1992 - 1993 Corvette: Service Bulletin: Noisy/Fraying Accessory Drive Belt

Subject: NOISY/FRAYING ACCESSORY DRIVE BELT (INST. SINGLE-SIDED BELT)

Model and Year: 1992-93 CORVETTE WITH 5.7L (LT1) ENGINE

Bulletin Number: 93-273-6A

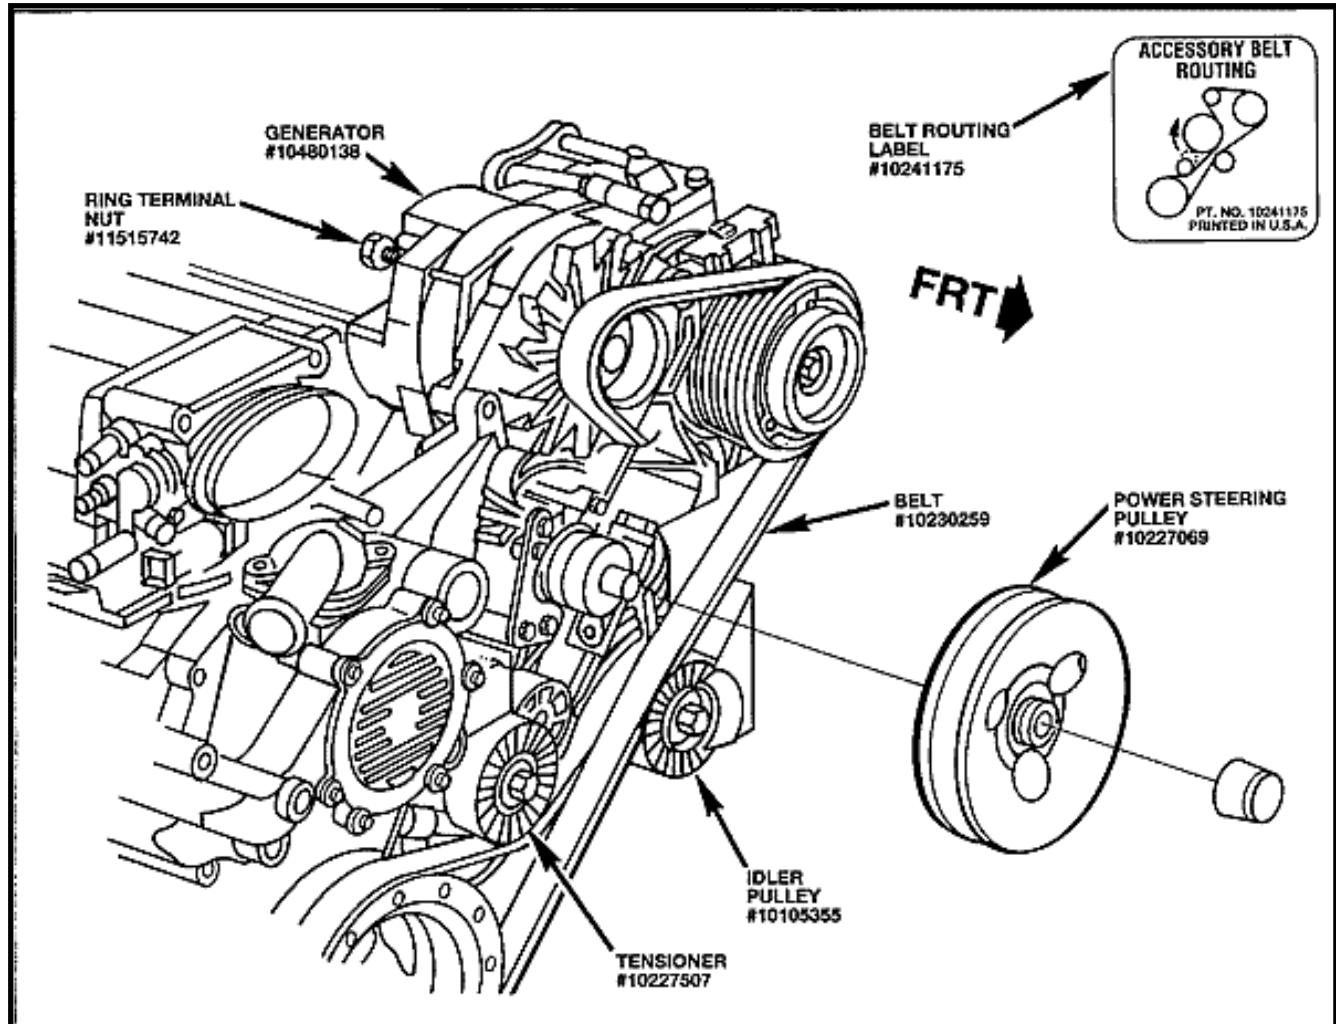
Some owners of 1992 and early 1993 model year Corvettes with 5.7L (LT1, VIN P) engines using the double-sided accessory drive belt may experience a noisy or fraying belt condition.

Inherent stresses and/or processing of the double-sided belt.

To correct this condition a change was made from the double-sided belt system to a new single-sided belt system. Starting the week of March 22, 1993, VIN breakpoint #1G1YY23P4P5113150 Corvettes with LT1 engines were built with the new single-sided belt. To repair older units with the double-sided belt to a single-sided belt, the following parts must be installed:

NEW PART NO. DESCRIPTION

10230259 Belt

10227507 Tensioner
10227069 P/S Pulley
10105355 Idler Pulley
10463533 Generator
11502811 Generator Ring Terminal Nut #M8

NOTE: When replacing the new generator, the ring terminal on the wire harness will have to be opened up the 8.5mm to accommodate the larger stud on the back of the new generator.
